SUBJECT: ISSUANCE OF AMENDMENT NOS. 168, 168, AND 165 TO FACILITY OPERATING
LICENSES DPR-38, DPR-47, and DPR-55 - OCONEE NUCLEAR STATION,
UNITS 1, 2, AND 3 (TACS 65768/65769/65770)

SAFETY EVALUATION BY THE OFFICE OF NUCLEAR REACTOR REGULATION
RELATED TO AMENDMENT NO. 168 TO FACILITY OPERATING LICENSE DPR-38

OCONEE NUCLEAR STATION, UNITS 1, 2 AND 3

Oconee Nuclear Station
Figure 3.5.2-15

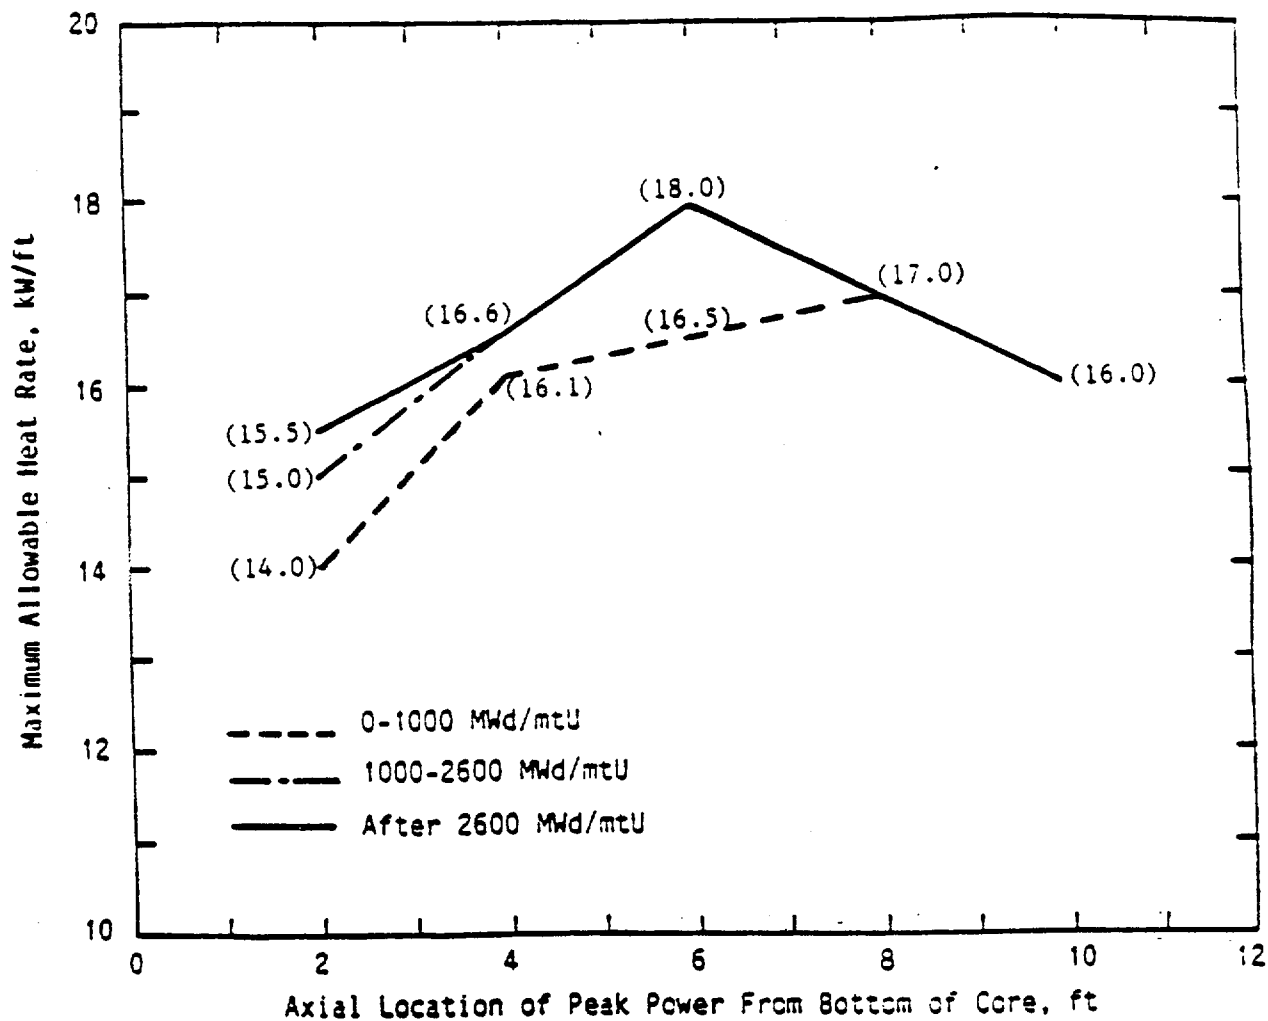
The amendments revise the Technical Specifications to update the LOCA-Limited Maximum Allowable Linear Heat Rates reflecting the effects of the NUREG-0630 models and the analytical results with use of the FLECSET correlation. By a January 22, 1988 letter, you state that you are supplementing the June 1, 1987 request. As we have discussed with your staff, we view these two letters as separate issues. Therefore with these amendments, we have approved the June 1987 submittal and are continuing our review of your January 1988 submittal. After completing our review, we will respond to the January 1988 letter by separate correspondence.

The proposed amendments would revise the LOCA-Limited Maximum Allowable Linear Heat Rate (Figure 3.5.2-16). These revisions would reflect NUREG-0630, Cladding Swelling and Rupture Models for LOCA Analysis and Babcock and Wilcox (B&W) Owners Group Topical Report BAW-1915P, Bounding Analytical Assessment of NUREG-0630 models of LOCA kilowatt-per-foot limits with use of FLECHT-SEASET.

BAW-1915P and BAW-10104, Revision 5 have been reviewed by the Commission and approved on October 5 and December 27, 1987 (References 3 and 4). These reports provide the technical basis for these revisions. The models addressed in these reports are used to determine the LOCA-Limited Maximum Allowable LHR. The proposed revision to Figure 3.5.2-16 reflects application of the new models.

The proposed TS revisions are to update the LOCA-Limited Maximum Allowable Linear Heat Rates reflecting the effects of the NUREG-0630 models and the analytical results with use of the FLECSET correlation (Reference 5). We have reviewed the proposed TS changes and find that the proposed LOCA-Limited Maximum Allowable Linear Heat Rates are consistent with the calculated results presented in Table 3.2 of Reference 5, which had previously been approved by the Commission (Ref. 3) for licensing applications for the B&W lowered loop 15x15 fuel assembly plants including the Oconee plants. B&W performed the large break LOCA analyses to support the request of the TS revisions by using the modified ECCS Evaluation Model as described in the B&W topical report BAW-10104, Revision 5. On December 27, 1987, we generically approved the topical report BAW-10104, Revision 5. The staff also found the plant specific application of the B&W topical report BAW-10104, Revision 5 to the Oconee plants to be adequate and acceptable. Therefore, we conclude that the proposed TS revisions are acceptable.
